SERVICE BULLETIN 1

BLISTERING OF FUEL MANIFOLD HOSE OUTER COVER

SERVICE BULLETIN 2

POSSIBLE INCORRECT POSITIONING OF MOUTH TAPES

Figure 1. INCORRECTLY INSTALLED MOUTH LOAD TAPE

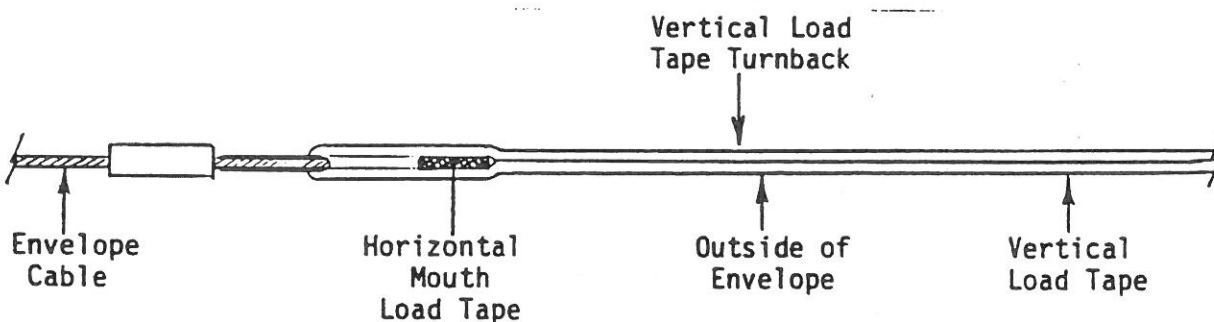
In several balloons, the mouth horizontal load tape may be incorrectly sewn sandwiched BETWEEN the two parts of the vertical load tape. The sketch below shows a side view of this INCORRECT assembly of the horizontal mouth load tape relative to the vertical load tapes:

Within the next 10 flight hours on the balloon, or before July 15, whichever comes first, inspect the mouth of the balloon to determine if the mouth horizontal load tape has been incorrectly installed. The sketch below is a side view showing the CORRECT assembly of the load bearing tapes at the mouth of a Cameron balloon.

Stitched: OK

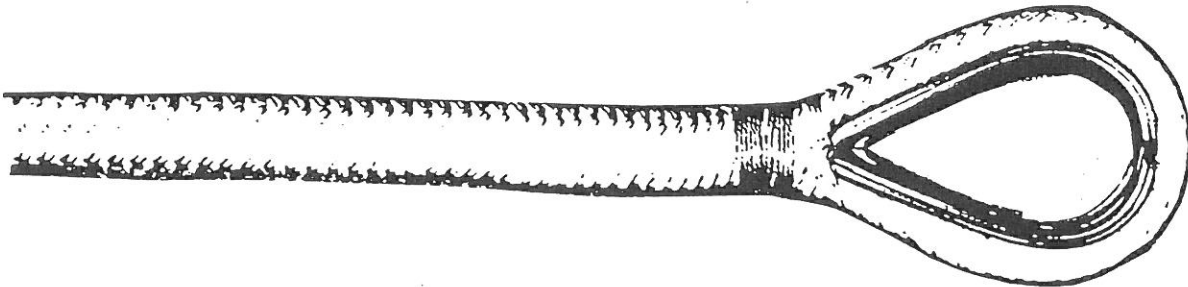
IF the eye splice is either stitched or whipped as shown in the photos labelled "Stitched: OK" or "Whipped: OK" on the attached sheet, THEN the inflation harness line is NOT from the suspect batch. In this case CHECK the "STITCHED" or "WHIPPED" box as appropriate on the enclosed Postal Reply Card and mail the card back to us. You may continue enjoying the benefits of using your current inflation harness rope.

7. Figure 1:

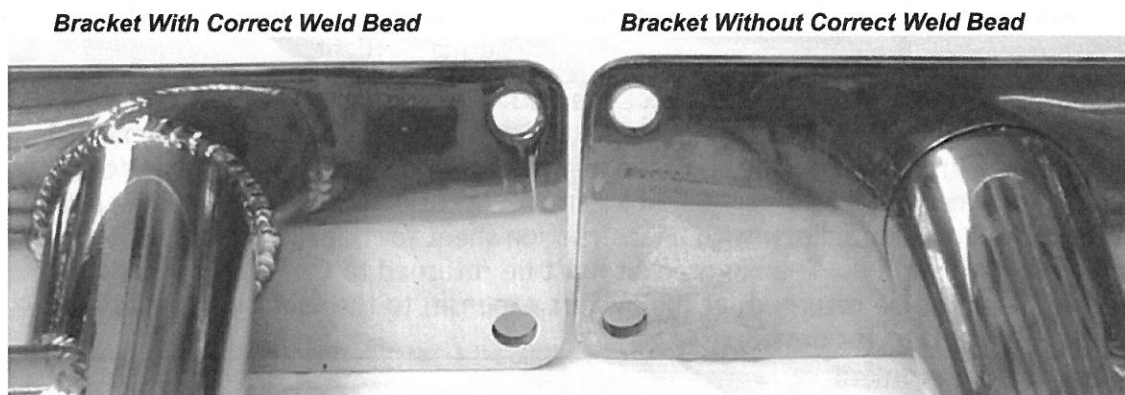
<p>5. Accomplishment Instructions: Inspect the burner mounting bracket for cracking. Refer to Page 2 of 3 Figure1. Cracked brackets must be replaced before the next flight. Non-conforming brackets must be replaced at the next Annual/100 Hour Inspection. Bracket replacement MUST be performed by an FAA certified Repair Station or Repair person. Replacement brackets, with an instruction sheet for Repair Stations or Repair Persons, will be provided. The old bracket must be returned to Cameron Balloons U.S. The burner may also be returned (at the owners expense) to the factory. Contact Cameron Balloons U.S. for details.</p>		
<p>6. Materials: Replacement Parts Ultra Quad Bracket - Part Number CB2252. Ultra Triple Bracket - Part Number CB2216.</p>

- 1) Hold the burner by the top of the coil and check for cracks at the positions indicated at the right.
- 2) Visually inspect the joint between the burner can support plate and the mounting tube. Check for a visible weld bead.

Existing Self Seal Valve replaced by cassette (Item 3)

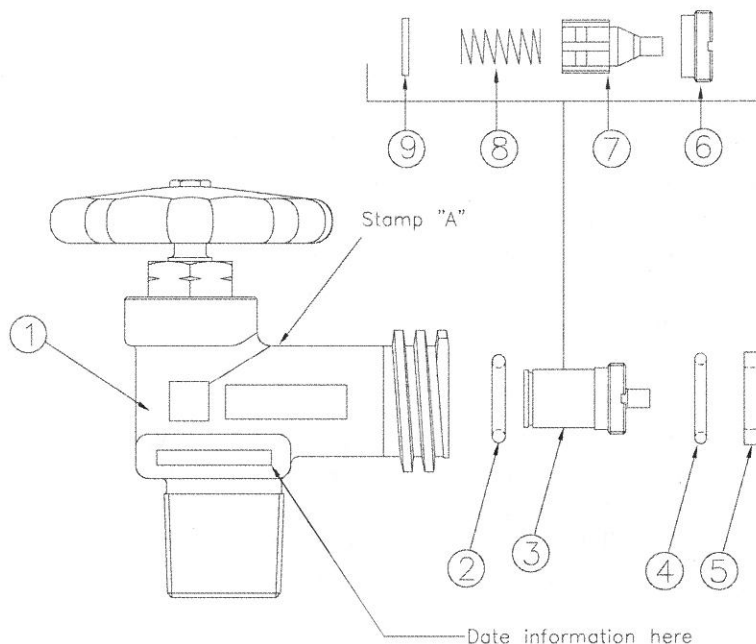
Procedure: Refer to diagram on page 5.

- 1) Ensure that the liquid valve is in the closed position.
- 2) Remove the outlet gasket (item 5) and outlet outer o-ring (item 4) and discard if damaged.

- 3) Unscrew and remove the self seal retaining ring (item 6). Use special tool part number F825T or equivalent.
- 4) Remove and discard the self seal (item 7), spring (item 8) and washer (item 9).

- 5) Remove and discard the outlet inner o-ring (item 2).
- 6) Fit new inner o-ring (item 2) (supplied with the repair kit).
- 7) Fit self seal cassette (item 3) (supplied with the repair kit) and tighten.

- 8) Fit outer o-ring (item 4) and gasket (item 5) with the supplied replacements.
- 9) Leak check.
- 10) Remove the handwheel (item 10).
- 11) Stamp a 1/4" tall 'A' on the topside of the outlet snout at the base of the bonnet assembly housing.

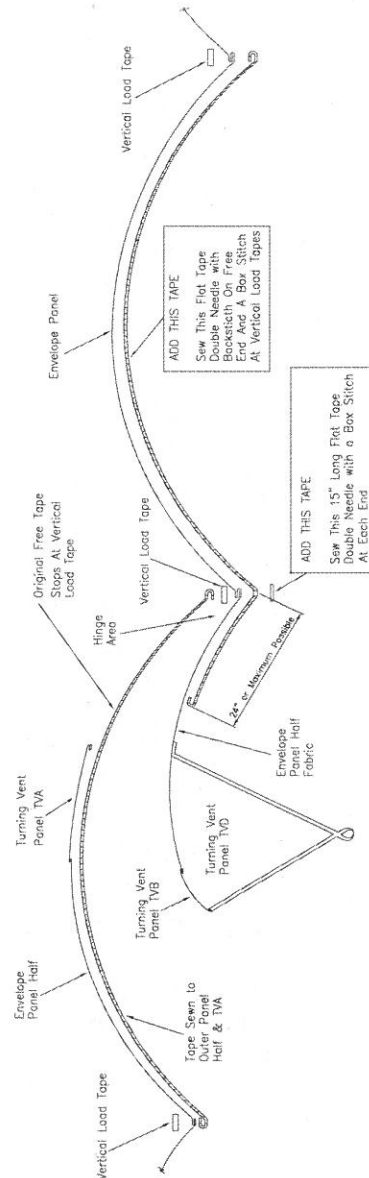
4. Consequences of Non-Compliance (Possible): During aggressive turning vent use in turbulence, and/or snagging during ground handling, it is possible for tears to occur in the fabric adjacent to the hinge

5. Accomplishment Instructions: At the next Annual/100 hour Inspection, install two 3/4" wide lengths of flat webbing to the inside of the envelope at all free tapes as illustrated on pages 2 and 3. Where there is a complete circumferential Horizontal Load Tape, the additional webbing does not have to be installed.

7. Figure 1:

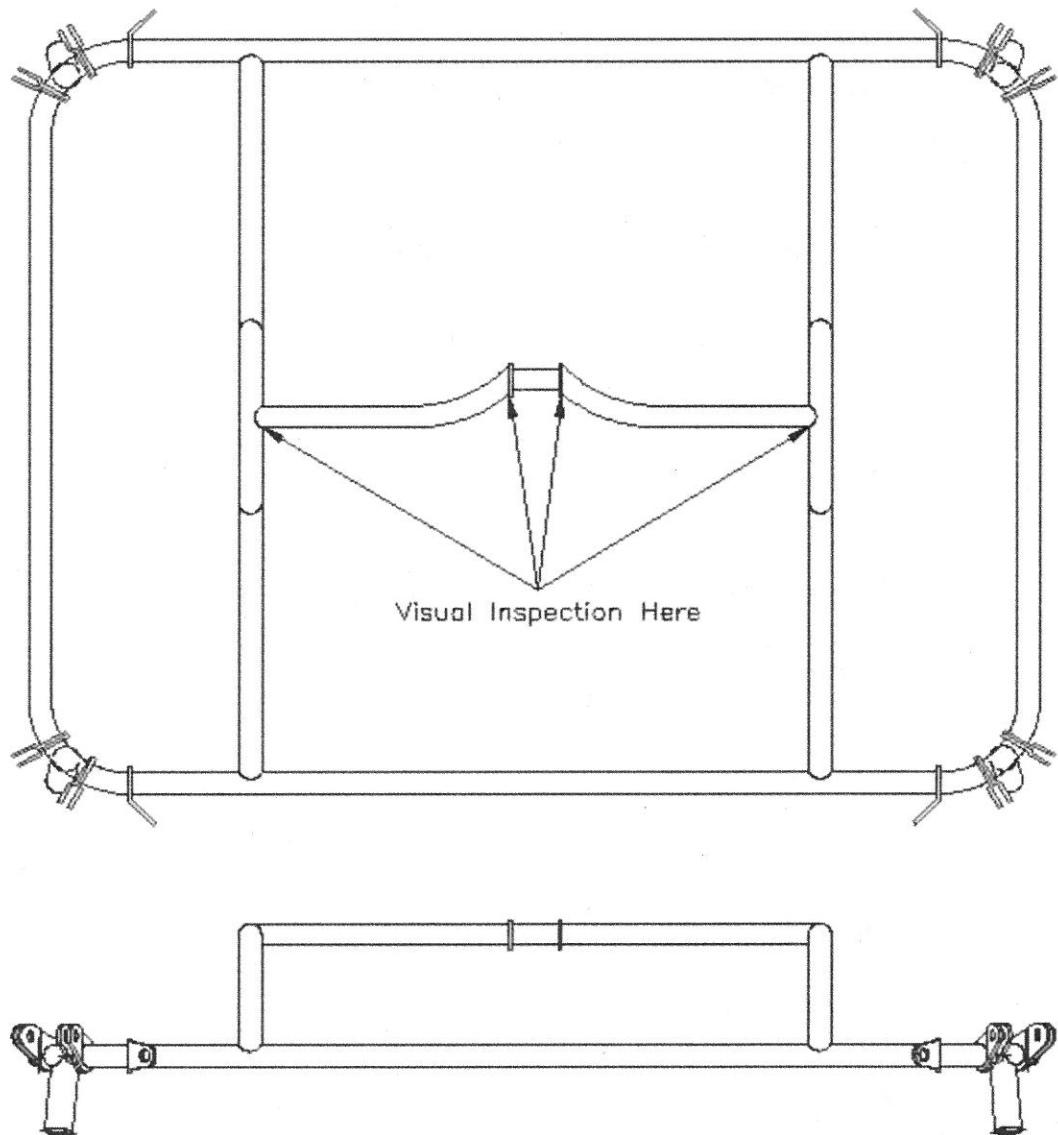
2. **Background:** There have been weld cracking and failures during road transport of the weld at the gimbal bearing (triple burner frame cross bar) and attachment of the cross bar to outer frame (triple and quadruple gimbal block burner frames). See Figure 1.

1. Visual Inspection (see Figure 1) through 360° at weld around gimbal bearing (triple burners only) and at attachment of cross bar to bridges on outer frame (triple and quadruple burners). This may be carried out by the owner/operator.
2. Remove from service any frame showing signs of cracking.
3. Report any rejections to Cameron Balloons US.
4. Cracked frames can be returned to service by following the instructions obtained from Cameron Balloons U.S.

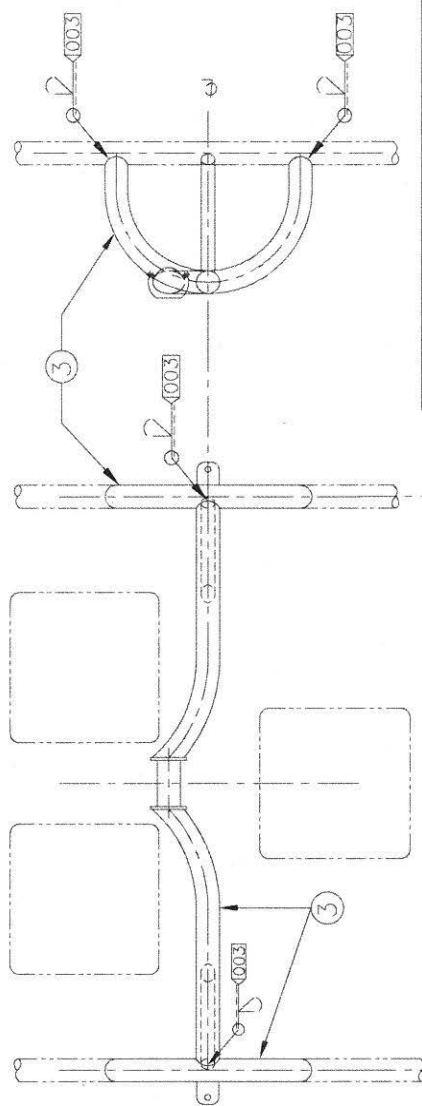
Triple:

The weld at the crossbar to the gimbal block stop rings uses Joint Type 2. Single-V Fillet weld. See page 4.

The weld at the crossbar to the hoop and both ends of the bracing tubes uses Joint Type 3. Tube to Tube Fillet Weld. See page 5.

1. Remove the Burner Assembly from the Frame
2. Weld the identified affected areas where cracks are found per the processes on pages 4 or 5. The braces must be notched to fit on each end prior to welding.

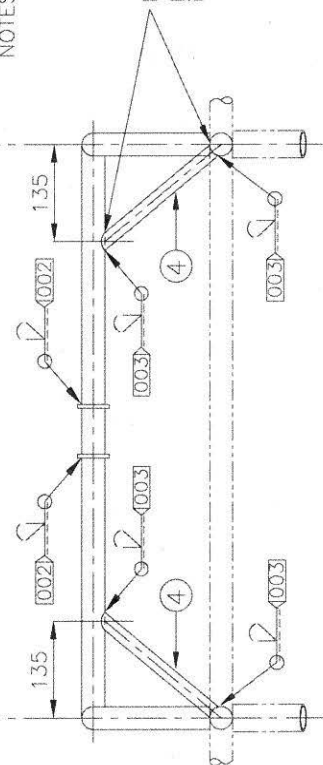
Notch each Item 4 tube to fit, per Joint Type 3 from included instructions.

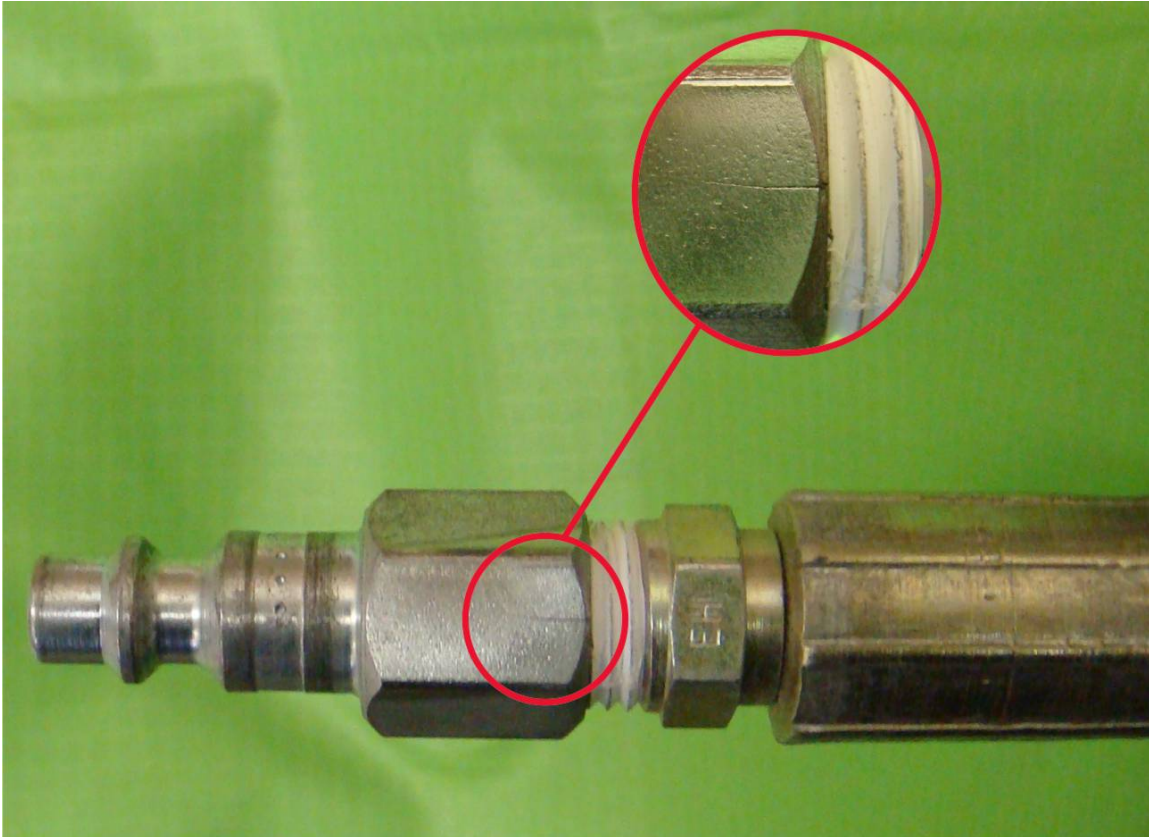
(e) Applicability:	Vapor Pilot Light Hoses delivered between February 2002 & April 2008
(f) Affectivity:	All Vapor Pilot Light Hoses
2. Background:	It has been found that several Vapor Pilot Light Hose Male Quick Connect Fittings may have a visible crack in the hex section of the fitting (see the picture below). There have been no leaks due to this condition due largely to the Teflon tape seal and the very low pressure at this fitting.

5. Accomplishment Instructions: Inspect both visually and with a gas leak detector (with the hose under pressure) the Vapor Pilot Light Hose Male Quick Connect Fitting for a crack in the hex section.

6. Materials:	If a crack is found, a new Male Quick Connect Fitting will be supplied free of charge. Contact Cameron Balloons US for a replacement.
7. Instructions:	Remove the damaged Male Quick Connect Fitting with a suitable wrench. Remove any Teflon tape residue from the threads on the hose end. Apply new Teflon tape to the hose end. Install the new Male Quick Connect Fitting on the hose. Take care to not over-tighten. The hose end is a male tapered pipe thread and acts a wedge. Over-tightening will split the fitting and cause a crack.
